SUBJECT: GUNNISON, COLORADO, PROCESSING SITE – REQUEST FOR
ADDITIONAL INFORMATION RE: DRAFT GROUNDWATER COMPLIANCE
ACTION PLAN

COMMENTS AND REQUEST FOR ADDITIONAL INFORMATION

DRAFT GROUNDWATER COMPLIANCE ACTION PLAN

GUNNISON, COLORADO, PROCESSING SITE

Figure 1. Uranium plume from Sector 1 and new gravel pit expansion (adapted from the 2018 Annual Verification Monitoring Report for the Gunnison Processing site Figure 2 (DOE, 2019))

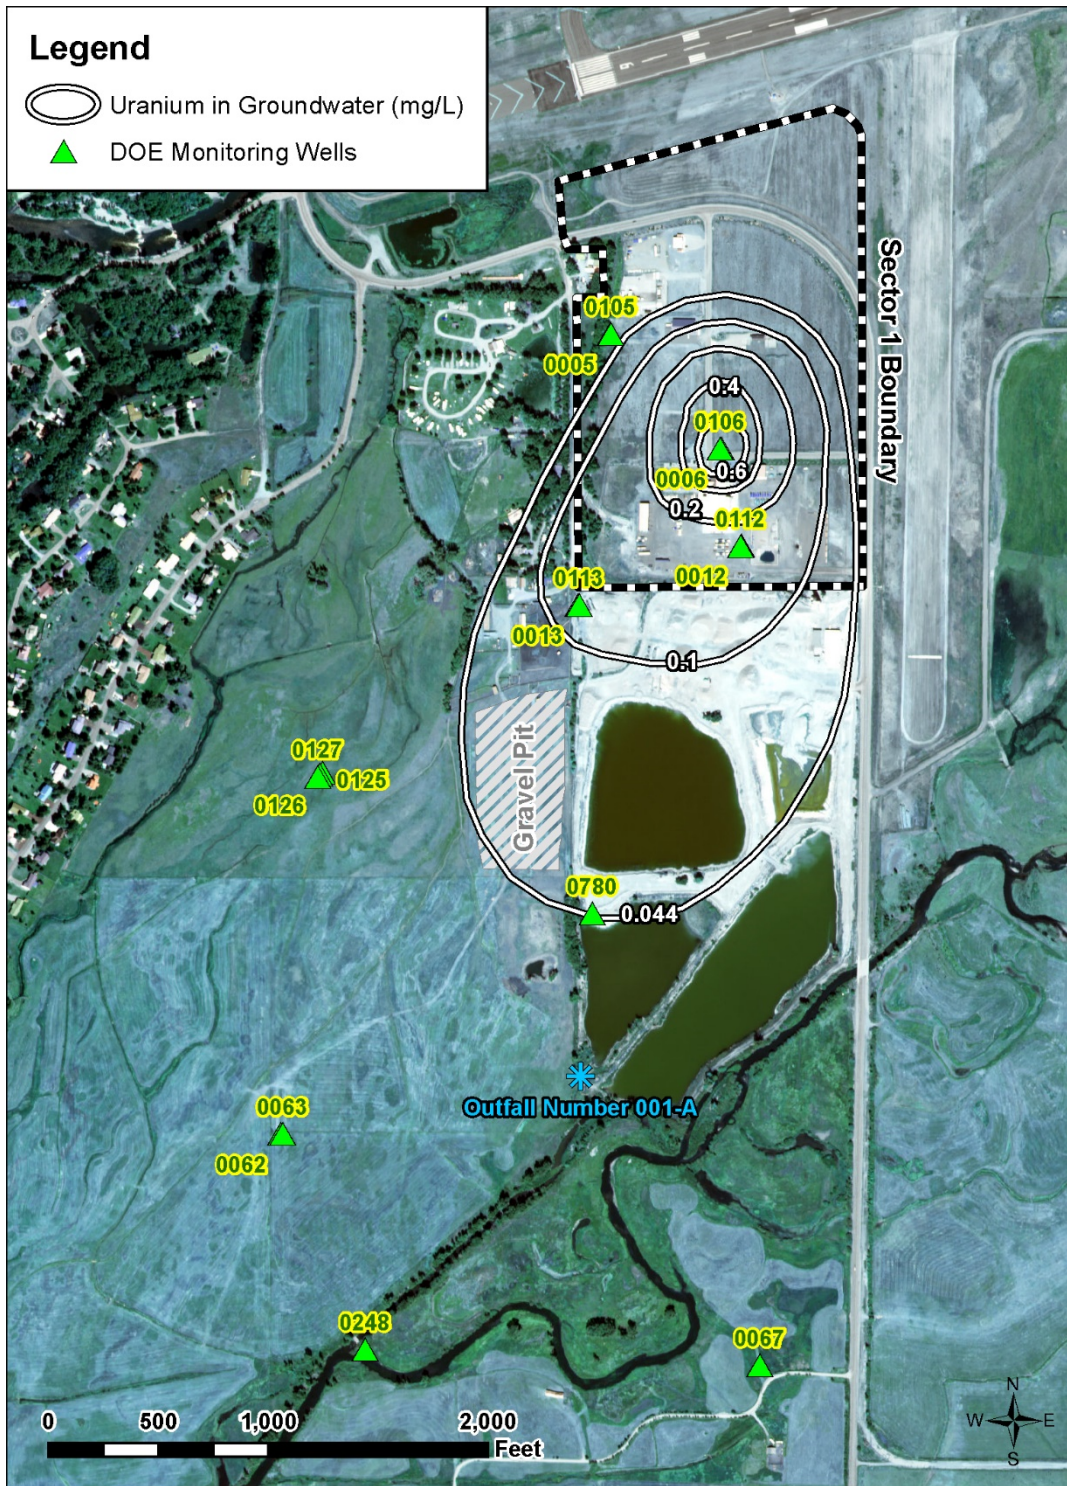
Comment 1: DOE has proposed a uranium Alternate Concentration Level (ACL) of 1.43 mg/l for all groundwater in the alluvial aquifer underlying the original Gunnison processing site boundary, renamed as Sector 1, in lieu of the original natural flushing remedy to the applicable uranium standard of 0.044 mg/l in Table 1 to Subpart A of Title 40 of the *Code of Federal Regulations* (CFR) Part 192 (DOE, 2017). NRC staff finds that the DOE has provided sufficient evidence that the current GCAP of natural flushing is unlikely to meet the applicable uranium standard of 0.044 mg/l uranium in proposed Sector 1. This finding is also supported by the current location of the uranium plume which exceeds the applicable uranium standard of 0.044 mg/l as shown below in Figure 1.

However, NRC staff finds that DOE has not adequately addressed the present and potential hazard factors in 40 CFR 192.02 c(3)(ii)(B)(1)(iv) and (v) required for a proposed ACL. In particular, DOE has not included an evaluation of changes in groundwater use, specifically the change in location for dewatering operations at the abutting gravel operations resulting from the recent approval of the Gunnison West Gravel Pit Expansion to the new location south of the proposed Sector 1 as shown in Figure 1. The application for this gravel expansion was submitted to Gunnison County in January 2017. It was approved by Gunnison County on July 26, 2017 (Certificate of Minor Approval, Certification No. 06 Series 2017).

NRC staff finds that DOE has not adequately addressed the present and potential hazard factors in 40 CFR 192.02 c(3)(ii)(B)(1)(iv) and (v) required for a proposed ACL by not addressing the groundwater use or analyzing the groundwater quality impacts expected from the expansion of existing gravel pit operations to a new location south of Sector 1 as shown in Figure 1. The application for this gravel expansion was submitted to Gunnison County in January 2017. The application was titled the "Gunnison West Gravel Pit Expansion" and was submitted by Oldcastle SW Group, Inc. dba United Companies as permit request LUC-17-00018. The application requested expansion of the sand and gravel operations for a new 7.5 acre gravel pit, up to 75 feet deep, directly west of the existing operational gravel pit as shown Figure 1. No other changes to the existing gravel processing operation were proposed. This permit was approved by Gunnison County on July 26, 2017 (Certificate of Minor Approval, Certification No. 06 Series 2017).

The new Gunnison West Gravel Pit Expansion operation was approved with new dewatering wells. In past gravel pit operations, dewatering wells have operated at rates up to 4000 gpm. These wells represent a new groundwater use south of the Sector 1 proposed ACL site. NRC staff finds the use of any new dewatering wells must be evaluated under present and potential hazard factors in 40 CFR 192.02 c(3)(ii)(B)(1)(iv) and (v). This evaluation is necessary to determine if and how the new gravel pit dewatering wells may impact the uranium plume and the uranium levels at the POE well MW0113 shown in Figure 1. In addition, the new dewatering wells are permitted to discharge to the "Valco Pond" gravel pit and may therefore impact the uranium levels in this gravel pond which are measured at SW0780.

Path Forward: NRC staff requests that DOE analyze the potential impact of any new gravel pit dewatering wells for the approved Gunnison West Pit Expansion. Specifically, DOE should determine if and to what extent the use of these gravel pit dewatering wells may impact the existing uranium plume shown in Figure 1 and the future uranium levels at MW0113. DOE has proposed MW0113 to be the Sector 1 POE well that will be required to meet the proposed Sector 2 ACL of 0.56 mg/l. NRC staff also requests that DOE evaluate any impact on the uranium levels measured at SW0780 in the "Valco Pond" gravel pit which will receive the dewatering well discharge from the new expansion gravel pit operation. The evaluation of this groundwater use and potential surface water impact is needed to meet the requirements of the factors in 40 CFR 192.02 c(3)(ii)(B)(1)(iv) and (v) for the proposed Sector 1 ACL.

Figure 2. Uranium plume from Sector 1 and uranium in downgradient (adapted from the 2018 Annual Verification Monitoring Report for the Gunnison Processing site Figure 2 (DOE, 2019))

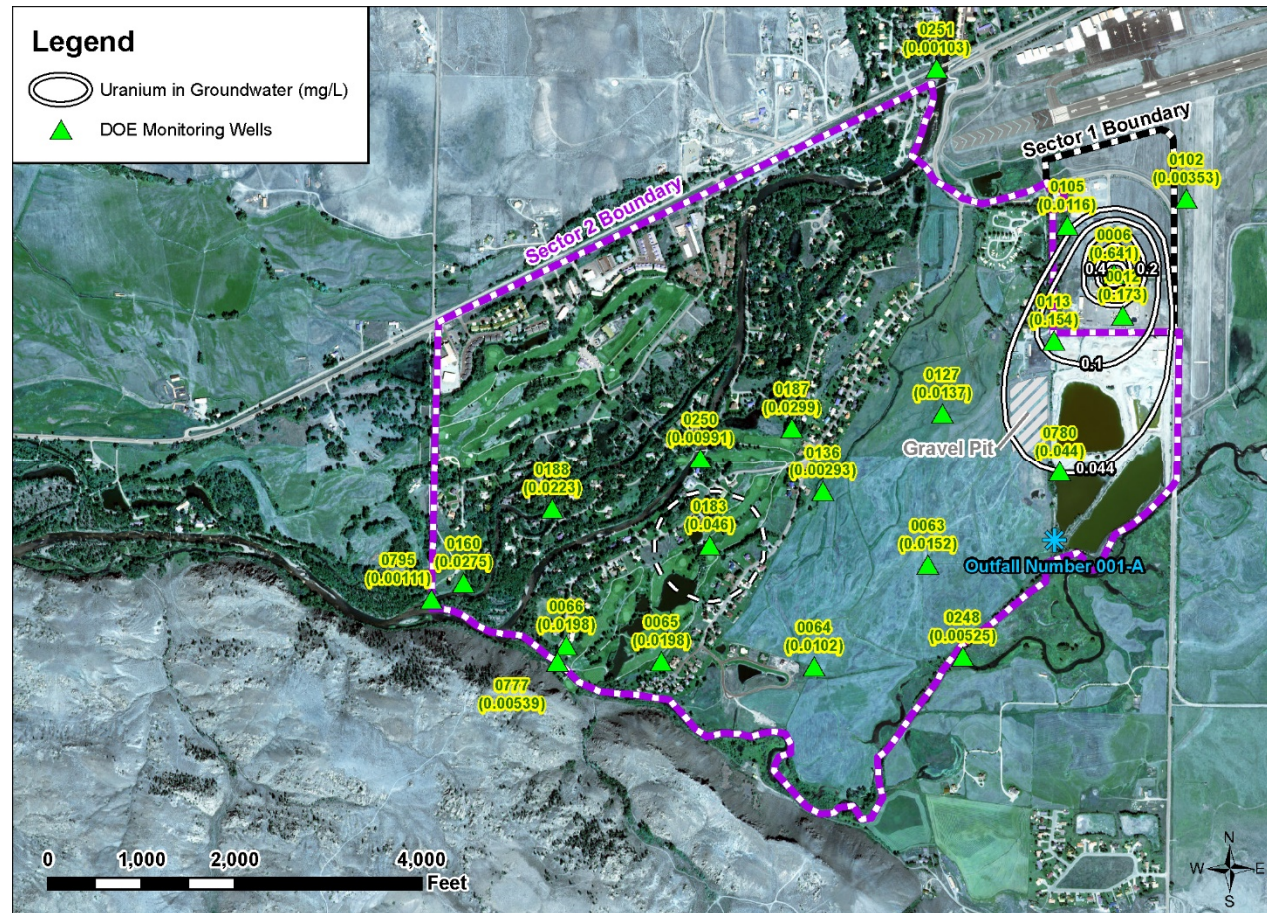
Comment 2: NRC staff does not agree that the current GCAP of natural flushing is failing or will fail to meet the applicable uranium standard of 0.044 mg/l in the entire area of proposed Sector 2 shown in Figure 2 below. In contrast, NRC staff finds the current GCAP of natural flushing is meeting and will continue to meet the applicable uranium standards of 0.044 mg/l for almost the entire Sector 2 area, excluding the area just south of Sector 1. Therefore, NRC staff does not understand the basis for DOE to propose an ACL of 0.56 mg/l for uranium in the entirety of Sector 2 which covers 928 acres (1.45 square miles) with an aquifer thickness ranging from 70 - 130 feet thick. Assuming an average thickness of 100 feet, NRC concurrence on this proposed ACL would permanently affect over 92,800 acre feet of water and is not justified. The NRC staff are concerned with the future use restrictions to such a large area of groundwater.

NRC staff, however, finds that DOE has not provided compelling evidence that the natural flushing remedy is failing for the downgradient plume in the entire alluvial aquifer in Sector 2 and that the goal of achieving the applicable uranium standard of 0.044 mg/l should be abandoned in lieu of an ACL. In contrast, NRC staff finds the natural flushing remedy has been and continues to be successful in the majority of the alluvial aquifer in Sector 2, with no compelling evidence that all of the alluvial aquifer in Sector 2 will exceed the applicable uranium standard of 0.044 mg/l.

In Sector 2, the groundwater moves to the southwest from the original Gunnison Processing site at a yearly rate of approximately 690 to 1150 ft/year according to hydraulic conductivity and gradient values provided in the revised GCAP (DOE, 2017). As shown below in Figure 2, the uranium concentrations in the downgradient monitoring wells across Sector 2 are all below the applicable uranium standard of 0.044 mg/l with the exception of a slightly elevated uranium level at MW0183 of 0.046 mg/l.

Path Forward: NRC staff requests that DOE should withdraw the proposed ACL for all of Sector 2 and maintain the natural flushing remedy to maintain the groundwater protection standard of 0.044 mg/l uranium to meet the groundwater protection standard as specified in paragraphs 40 CFR Part 192.02(c) (3) (i) (A) and (B).

Figure 3. Uranium levels in MW0113, MW0126 and MW0127 vs. applicable uranium standard (0.044 mg/l)

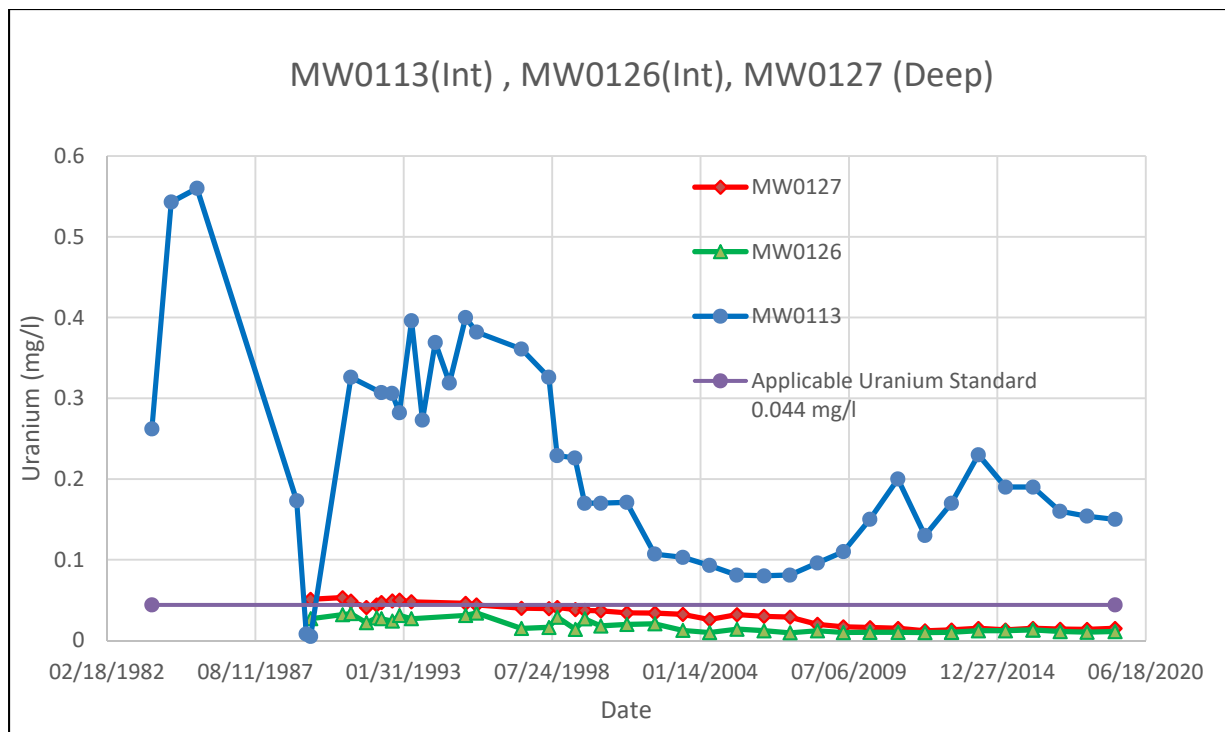
In its review, NRC staff found that DOE based the increasing trend in uranium and therefore failure of the natural flushing remedy in all of Sector 2 mostly on one well, MW0113, which lies immediately adjacent to the southwest corner of the original processing site as shown in Figure 1. DOE showed this upward trend as a deviation from the predicted natural flushing model in Figure 4 of the draft GCAP (DOE, 2017).

NRC staff's independent review of the monitoring well data for MW0113 is shown in Figure 3 below. The uranium levels in this well showed a significant decrease in uranium from 0.56 mg/l to 0.081 mg/l, from 1985 to 2007. The well then displayed a mild increasing trend up to 0.23 mg/l uranium from 2008 to 2014. However, from 2015 to 2019, the MW0113 data shows the upward trend in uranium has reversed and is now stable around 0.15 mg/l uranium as shown in Figure 3. In addition, the NRC staff's review of wells immediately downgradient of MW0113 showed this increase was not reflected in the downgradient wells, even though it was present for seven years. Specifically, MW0126 and MW0127, also shown on Figure 3, are the closest wells located 1039 feet directly downgradient of MW0113. These wells show significant decreasing trends with natural flushing in Figure 4 and have remained significantly below the 0.044 mg/l uranium standard since 1998. NRC staff review of these wells and of all other downgradient wells in Sector 2 indicate that the anomalous increase in MW0113 was naturally attenuated as predicted and did not impact downgradient wells.

NRC staff finds that the only well in Sector 2 that had a brief increasing trend of concern was MW0113 located in the far northeastern border of Sector 2 on the southwestern corner of the original Gunnison processing site identified as Sector 1. NRC staff found the increasing trend in uranium in the MW0113 has reversed and is now declining. In addition, NRC staff finds this well is immediately adjacent to the original processing site and is therefore not representative of all the downgradient wells in Sector 2 which remain substantially below the applicable uranium standard of 0.044 mg/l. NRC staff finds this well is not representative of the entire Sector 2 downgradient water quality and is not impacting downgradient wells. It should therefore not be used as the main basis to propose an ACL for Sector 2.

Figure 5. Example of revised Sector 2 (purple boundary) for proposed ACL (adapted from the 2018 Annual Verification Monitoring Report for the Gunnison Processing site Figure 2 (DOE, 2019))

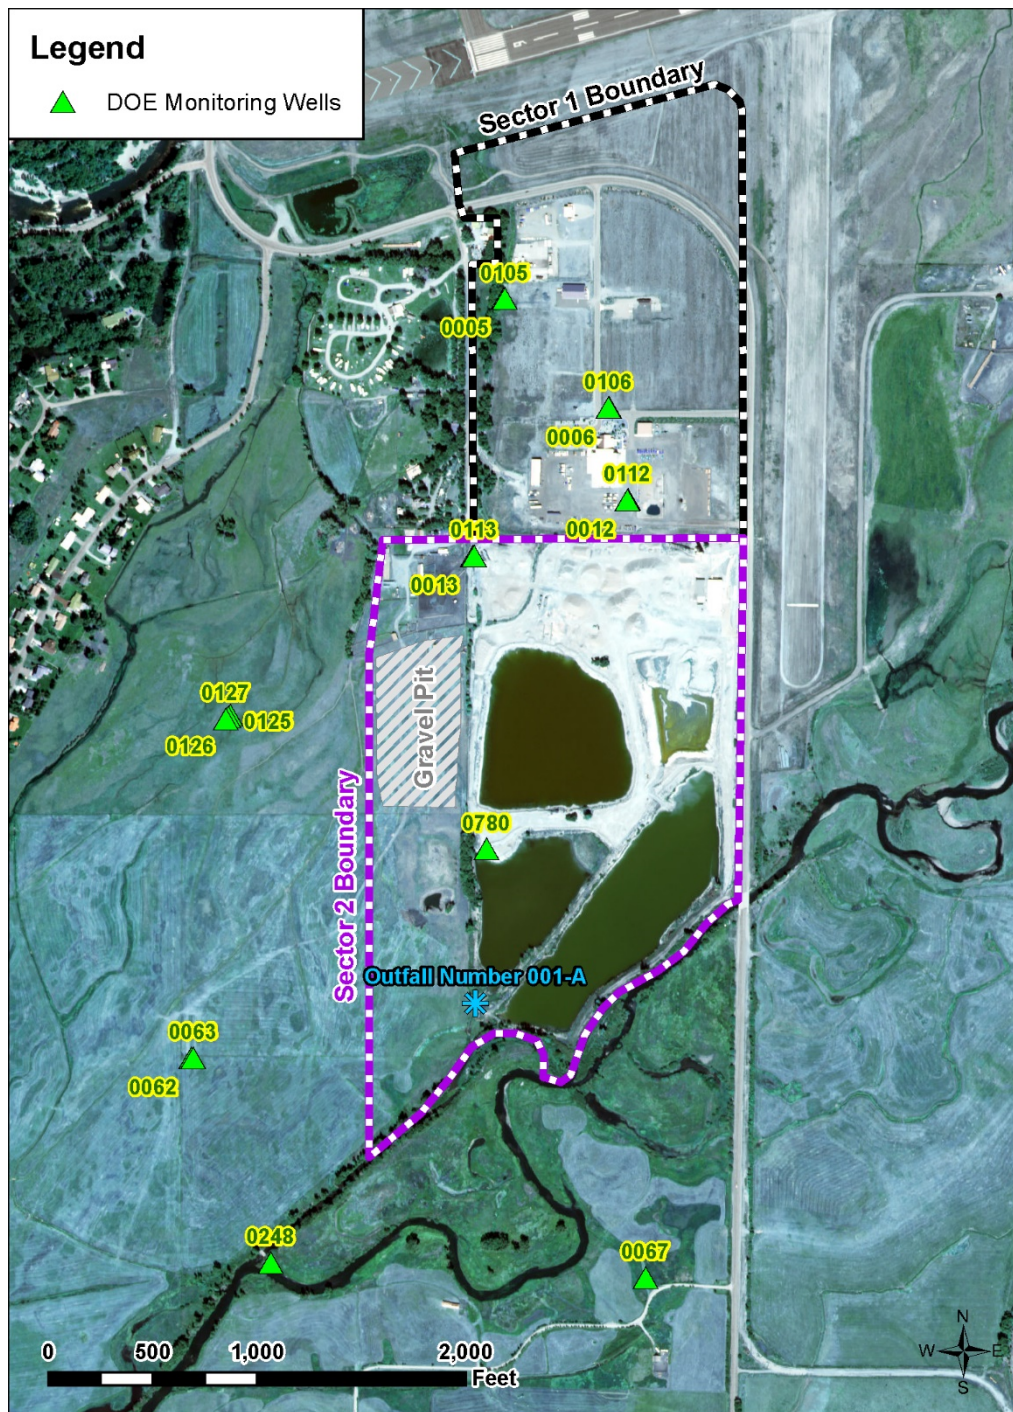
Comment 3: NRC staff requests that DOE propose a revised Sector 2 from the southern boundary of Sector 1 down to Tomichi Creek to include MW0113, the entire gravel pit operation and newly approved Gunnison West gravel pit expansion. An example of such a revised Sector 2 is shown in Figure 5 below. NRC staff finds there is compelling evidence that the alluvial groundwater in this revised Sector 2 will not achieve the uranium applicable standard of 0.044 mg/l in 100 years by natural flushing and therefore a proposed ACL of 0.56 mg/l derived from MW0113 historical uranium values is appropriate.

Basis: NRC staff finds that the proposed ACL of 0.56 mg/l uranium would be reasonable over a revised Sector 2 area extending south from the boundary of Sector 1 to Tomichi Creek and encompassing MW0113 and the new gravel pit operation to the west. An example of a revised Sector 2 area is shown in Figure 5 below.

Comment 6: NRC staff finds that there are no POE wells outside of the institutional control (IC) boundary directly south of the gravel pit operation in revised Sector 2 (Figure 5). A POE well is needed south of this IC boundary to monitor and ensure that unrestricted groundwater use will not pose a substantial present or potential hazard to human health and the environment.

Path Forward: NRC staff requests that DOE should reduce the Sector 2 area for the proposed ACL of 0.56 mg/l uranium to a revised Sector 2 area similar to the one shown in Figure 5 based on DOE’s own assessment.

Figure 6. Uranium levels in SW0248 and SW0780 vs. applicable uranium standard (0.044 mg/l)

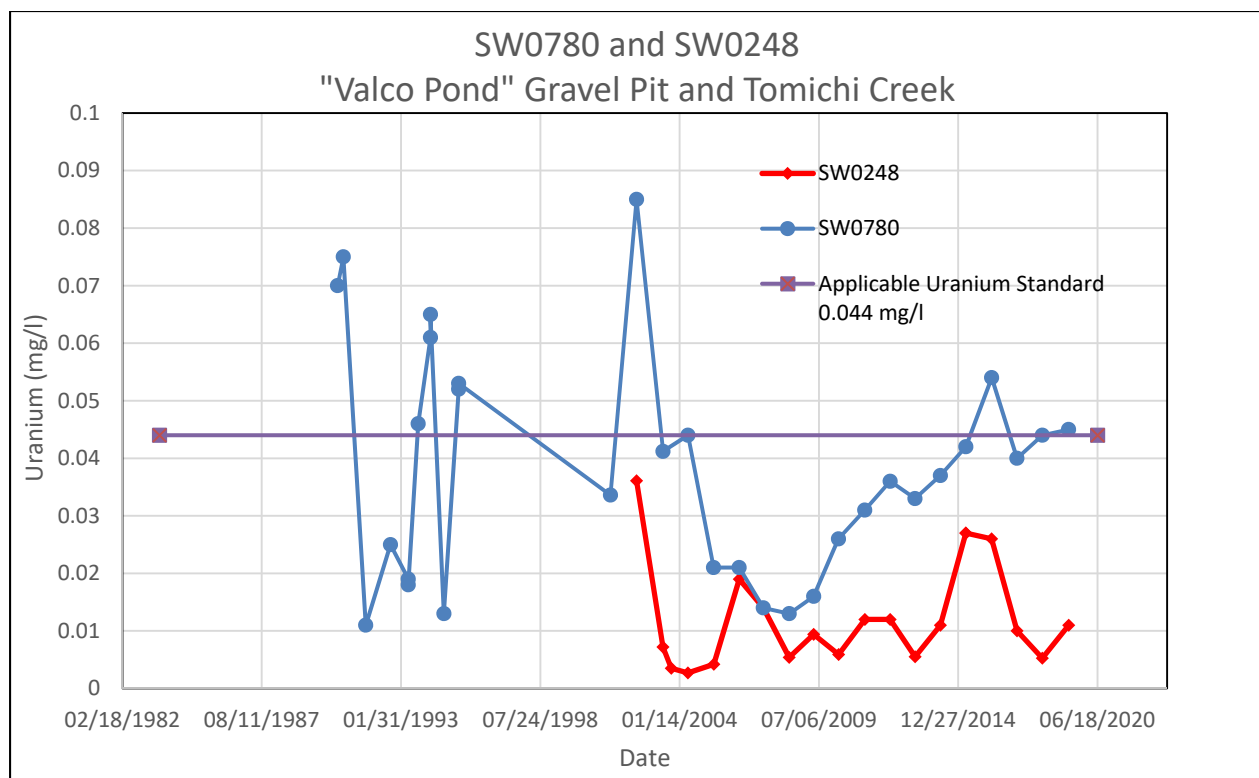
4. The uranium levels in SW0780 over time at the “Valco Pond” gravel pit within this revised Sector 2 have been below the applicable uranium standard of 0.044 mg/l but are now increasing above it as shown in Figure 6 below.

6. SW0248 is appropriate as a surface water POE because it has been consistently below the applicable uranium standard of 0.044 mg/l as shown in Figure 6 below.

Path Forward: NRC staff requests that DOE selects the groundwater well POE locations to be MW0125, MW0126, MW0127 and MW0062 and MW0063 and the surface water POEs to be SW0780 on the ‘Valco Pond’ gravel pit and SW0248 on Tomichi Creek for an appropriately revised Sector 2.

Figure 7. Uranium Trend in MW0067 and MW0082 vs. Applicable uranium standard (0.044 mg/l)

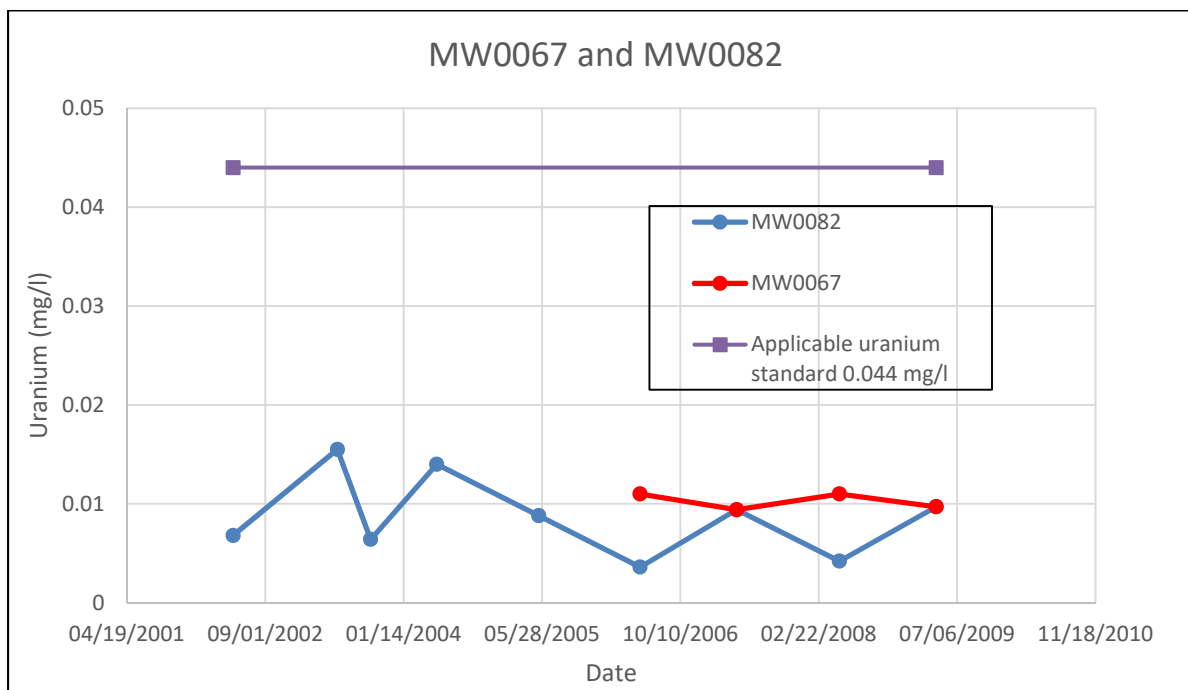
NRC staff finds groundwater must be suitable for unrestricted use downgradient of a revised Sector 2 as there are no ICs beyond this boundary. DOE measured uranium concentrations in private domestic wells MW0080, MW0081, and MW0082 just south of the Sector 2 gravel pit boundary in the past. Some of the uranium measurements in these domestic wells were elevated relative to background, but below the applicable uranium standard of 0.044 mg/l. In 2005, DOE installed MW0067 shown on Figure 5 to verify elevated uranium concentrations measured in

private domestic well MW0082 were representative. DOE monitored MW0067 for four years as shown in Figure 7 below.

DOE has not provided any uranium measurements in MW 0067 since 2008. To concur on an ACL for the recommended revised Sector 2, NRC staff must have an analysis that demonstrates that domestic groundwater users south of the IC boundary for a revised Sector 2 will not be exposed to uranium levels above the applicable standard of 0.044 mg/l.

Path Forward: NRC staff requests that DOE provide an analysis to support the conclusion that uranium concentrations in the alluvial aquifer will not exceed the applicable uranium standard of 0.044 mg/l beyond the IC boundary south of the gravel pit operations in a revised Sector 2. This information should include updated modeling with recent site monitoring data as well as additional groundwater monitoring data beyond the IC Boundary to the south and west of the former processing site in Sector 1. NRC staff also requests that DOE add a POE well, such as MW0067, if it still exists or install a new POE well in this area to verify that the proposed ACL for Sector 2 is protective of private well users.
